APPLICATION TO MAKE A NON-MATERIAL CHANGE TO THE OAKLANDS FARM SOLAR PARK ORDER 2025 (SI 2025/739) AS CORRECTED BY THE OAKLANDS FARM SOLAR PARK (CORRECTION) ORDER 2025 (SI 2025/1070)

Following the end of the consultation period and the submission of additional information by the Applicant as requested by the Environment Agency, the Secretary of State for Energy Security & Net Zero (“SoS”) has issued a Request for Information (“RfI”) dated 26 August 2026 requesting additional detail, information and clarity on the NMC application. This letter provides a response by the Applicant to the RfI following the structure set out in the RfI from the SoS. Appendix A includes statements from the relevant consultants in response to the RfI which have informed the Applicant’s response to the RfI.

OAKLANDS FARM SOLAR PROJECT DCO - NON-MATERIAL CHANGE APPLICATION – RESPONSES TO SOS REQUEST FOR INFORMATION

Figure 1 Visual representation of Change No.2 on panel heights

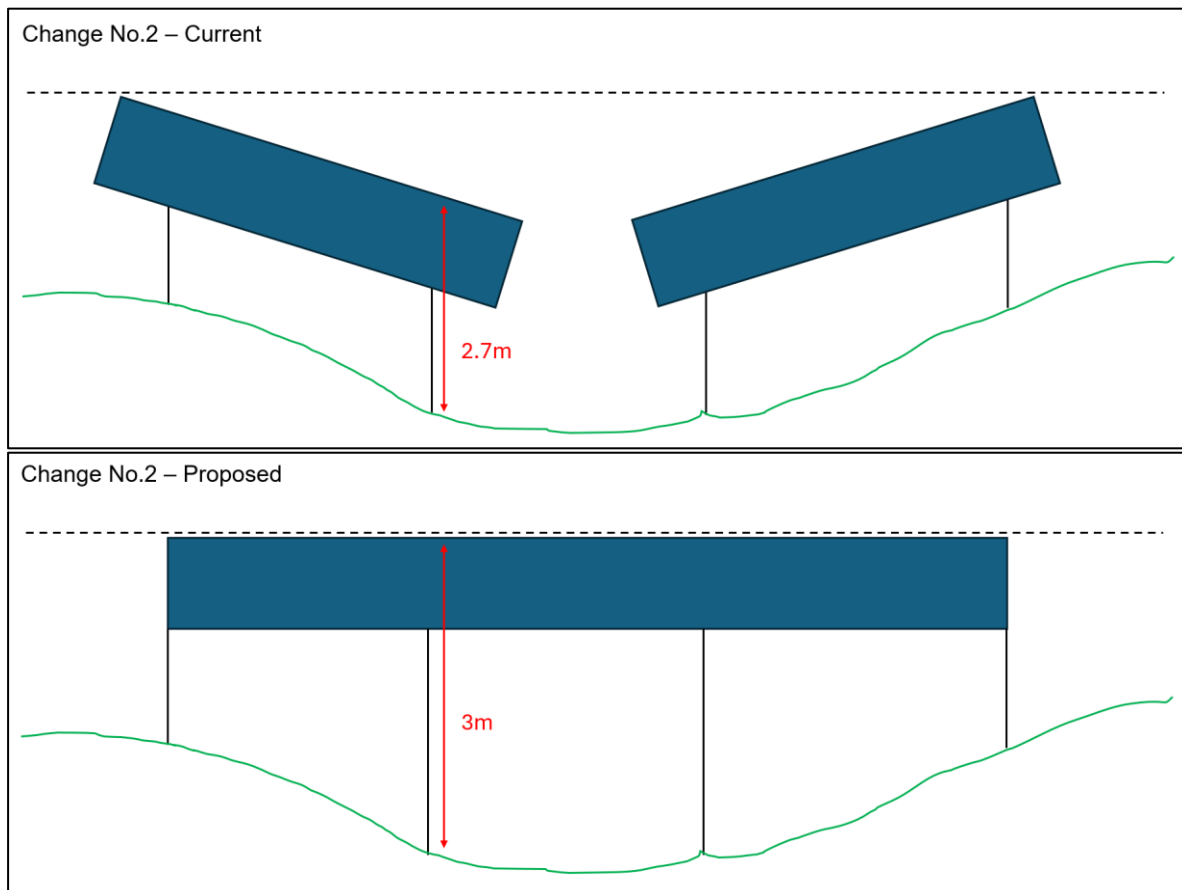
4. The Applicant is requested to confirm if the original glint and glare assessments remain valid for both the proposed increase and decrease to heights of the solar panels.

4. **The Applicant** is requested to confirm if the original glint and glare assessments remain valid for both the proposed increase and decrease to heights of the solar panels.
5. **The Applicant** is requested to confirm if the use of the 2.1m glint and glare screens will remain the same or if the height of these screens will increase to mitigate the proposed changes to the solar panels.

The proposed change (change 2) does not increase the maximum elevation of the solar panels Above Ordnance Datum (AOD). Rather, it provides some flexibility in the 2.7m height parameter where the existing ground level dips or falls away beneath the panels. This is necessary because the solar panels are installed on level mounting frames, or 'tables', which can extend across areas where ground levels vary. In these locations, the distance between the ground and the top of the panels may exceed 2.7m, even though the overall elevation of the panels remains unchanged. To account for greater topography variation, whilst ensuring the panel elevation remains the same and the maximum height above ground does not exceed 3m, the distance between the ground and the bottom of the panels may be less than 0.8m above ground level but no lower than 0.5m above ground level.

Without this flexibility, the solar tables would need to be unnecessarily broken up or stepped to follow relatively minor changes in ground level simply to maintain the minimum and maximum panel heights at every point. This would result in a more fragmented and less efficient layout. The change therefore allows the mounting tables to remain level across the natural variations in the site's topography. Importantly, it does not result in the panels being installed at a greater overall elevation; any increase above 2.7m from ground level occurs where the land falls away beneath the panels. The difference between the two approaches is shown through a pronounced¹ visual representation in Figure 1 on the following page. The figure shows that the panels keep a consistent maximum elevation AOD (black dashed line) and only the height relative to dip in terrain will increase.

¹ The topography in the figure is far more pronounced to show how the terrain variation will change the maximum panel height above ground level. In practice, the variation will be far less severe and the difference is capped at 0.3m.

Both the changes in the minimum and maximum parameter heights for the solar panels therefore ensures the overall panel heights and the tables remain a consistent height as assessed in the Environmental Statement (“ES”). Therefore, the assessed height of the panels and the maximum elevation of the panels on which the glint and glare screening heights have been determined have not changed.

Overall, the original Glint and Glare Assessment remains valid as set out in ES Chapter 14 – Glint and Glare [REP04-047].
